One other item, and then I believe I am done with this. On the diagram, the words EV Charging Only are not striped on the ground in the non-accessible station. I would presume they should be - I was under the impression that all EVCS are reserved for charging only, regardless of whether they are van, accessible, ambulatory, or none of the above. Otherwise people will park there if it is not reserved for EV. Just another thought.

**STATE OF CALIFORNIA
BUILDING STANDARDS COMMISSION**

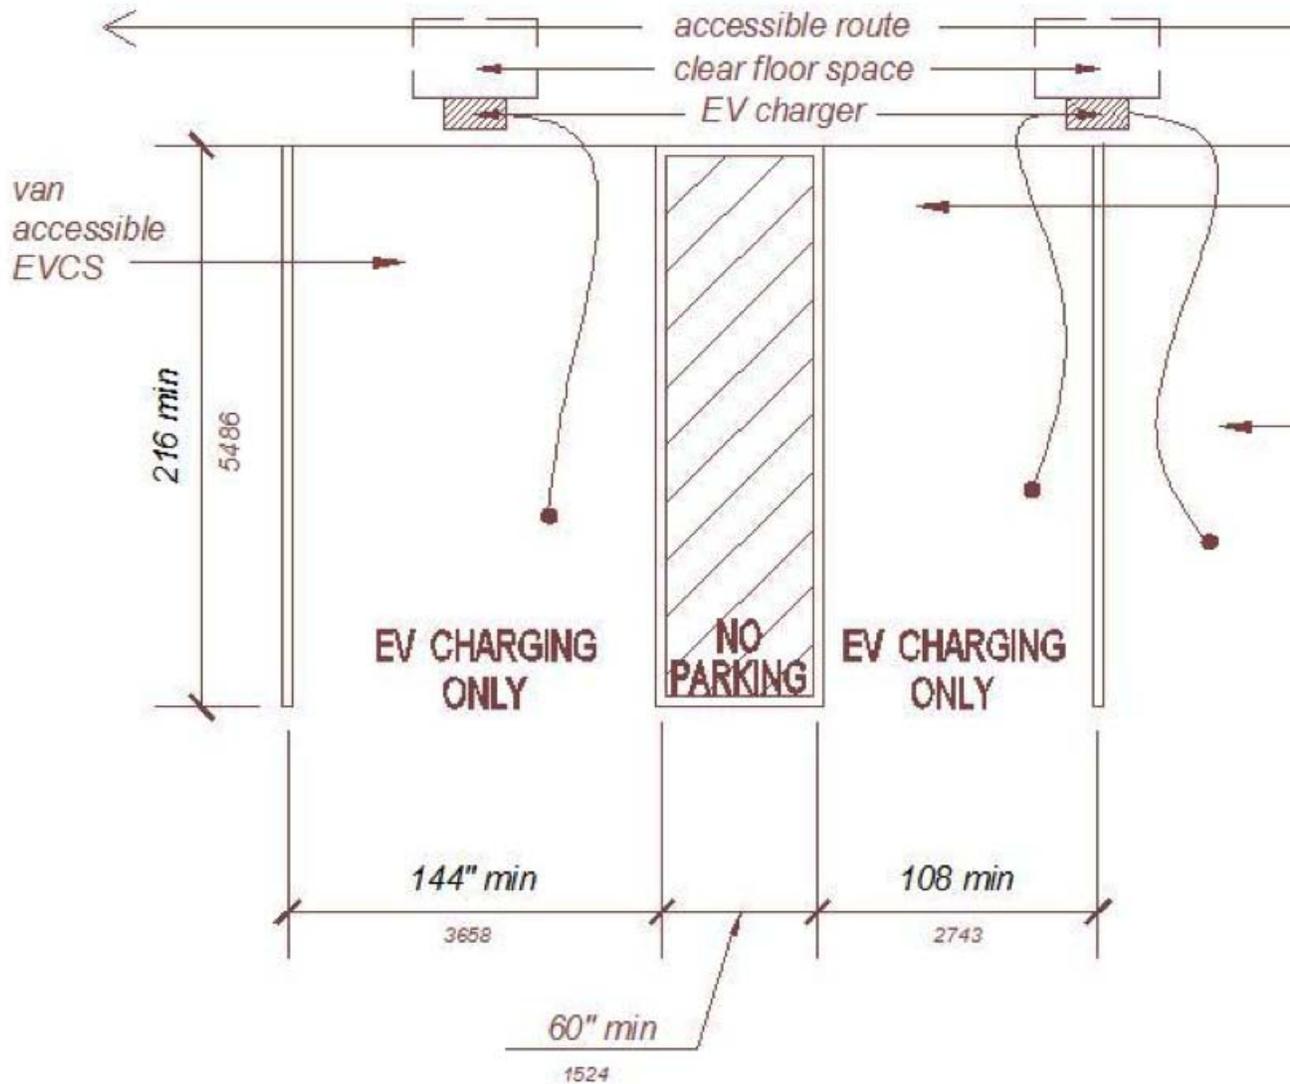
Confusion for Drive-up spaces. The space requires to be 17' wide and does not require markings to define the width nor any access aisle. Does this mean that I need a line at the head and foot of the pull-up space demarcating the 20' length? If it does, this marking extends for a 17' distance? This could be strange sticking out into what might be a passing drive aisle. Does this mean that if I had 2 side by side charging stations can this 17' wide space overlap for each - if so how much?

Below is a sketch from what I am reading from the code - is this the intent and the location for the charger? The striping? The identification painted on the ground?
